OLD ORCHARD BEACH PLANNING BOARD March 2018 MEMO

March 2018 Planning Board Memo: Table of Contents

ITEM 1: Subdivision Amendment: Deshaies Ross Road	PAGE 2
ITEM 2: Private Way: Deshaies Ross Road	PAGE 5
ITEM 3: Subdivision Amendment: 8 Lot Subdivision.	PAGE 14
ITEM 4: Ordinance Amendments: Contractor Business in Rural District	PAGE 10
ITEM 5: Ordinance Amendments: Medical Marijuana Storefronts	PAGE 20
ITEM 6: Site Plan: Dollar General.	PAGE 23
ITEM 7: Major Subdivision: Red Oak	PAGE 30
ITEM 8: Major Subdivision/Site Plan: Church Street Station	PAGE 38

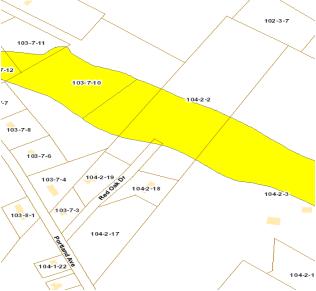
The house adjacent to Lot 9 on the other side of the stream was just completed this past summer. On the approved plans from 2005 it shows this lot as part of Phase II (*see attached plans*). In addition, the parcel number (104-2-2) on the Town's GIS shows that house as part of the same MBL as these 9 additional units. It is unclear on the sketch plan whether this lot is considered part of Phase II as shown on the 2005 approval.

It's unclear whether or not Lot 1 is a buildable lot. A detention pond was constructed this past summer in that area and it's unclear where the building envelope for this new lot is in relation to the pond. It's recommended that this pond be shown on the plan. The building envelope shown to the left of the stream is in the same area as the pond which was located within 25 feet of the stream (*see attached photos*).

FEMA implications – 3 or more of the proposed lots are in the designated FEMA flood zone "A." This is also addressed in the Wright Pierce memo from Stephanie.

One of the building envelopes for Lot 9 is tucked in the corner of the lot, how could an access drive be put in to get to this building without impacting the stream?
